Subject: Oyster Creek Generating Station
Docket No. 50-219
Facility Operating License No. DPR-16
Technical Specification Change Request No. 281
Supplement to Response to Request for Additional Information

Technical Specification Change Request No. 281

Supplement to Response to Request for Additional Information

Figure 1 - Elevation View of Typical End Truck and Bridge Connector Member

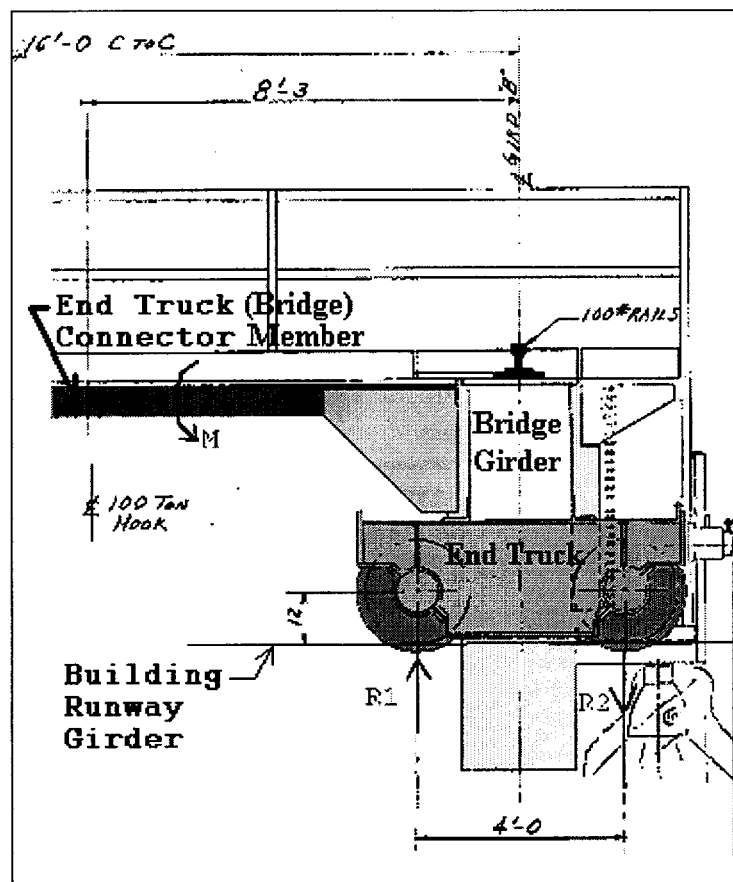
Attachment H, Page H10: How much does the stress interaction ratio exceed 1.33?

Describe the energy absorption method used to justify that the member in Question 5 is adequate.

The energy absorption technique determined the plastic hinge rotation capacity using commonly accepted engineering principles and compared it to the demand placed on it. A method of checking the plastic hinge rotation demand versus capacity is to compute the moment that would be required to deform the end truck to the point where the rotation in the connector member reaches its plastic hinge rotation capacity then compare the computed moment against the moment resulting from the seismic analyses. If the seismic analysis moment is smaller, then the rotation demand on the connector member is less than its capacity.

A free-body diagram representing one of the bridge end trucks and connecting members (illustrated in Figure 1 above) is shown below on Figure 2. Node and element numbers corresponding to the STARDYNE finite element model are marked on Figure 2. Note that the vertical stick member (BM 33) representing the cross section of the bridge girder is modeled as a
